Subject: Final Status Report for Decommissioning
Control Number: 137512

Re: West Virginia University Institute of Technology
NRC License No. SNM-1990, Docket 07003071

Additional Information

RADIATION SAFETY SURVEY

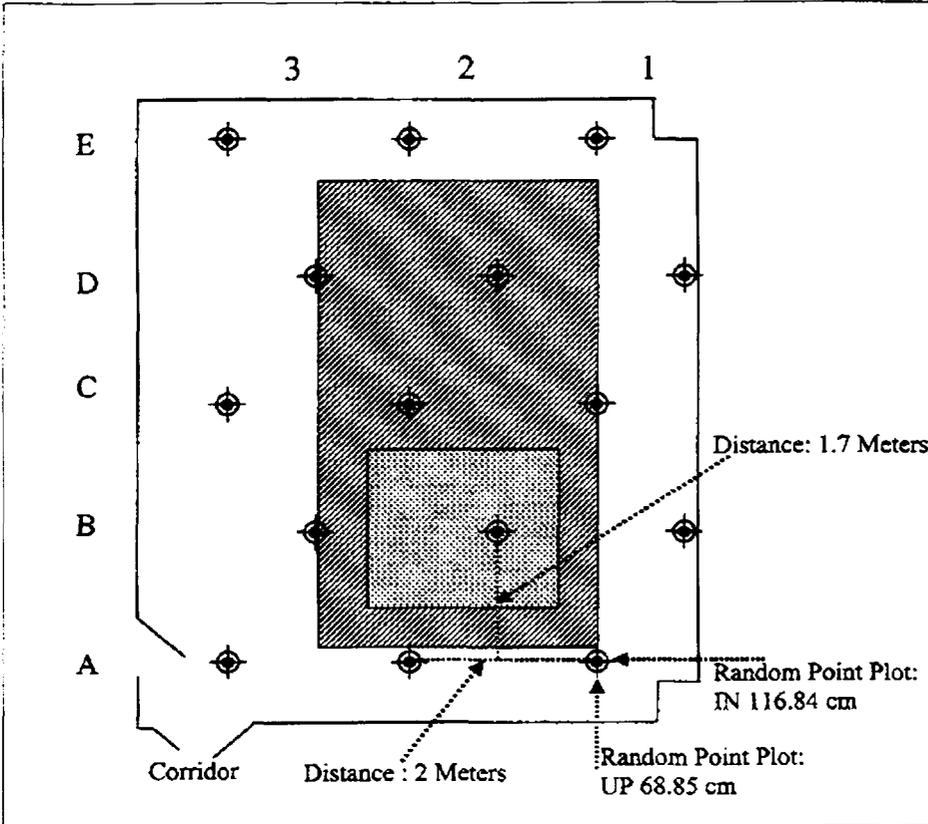
- b. Specify the calculations and the instrument efficiency that was used to determine the results of the static measurements in the "Radiation Safety Survey"; using the efficiency of 0.12 stated in Table 10, we cannot replicate the results.

A corrected report is attached. All results remain less than the DCGL. Attachment 2
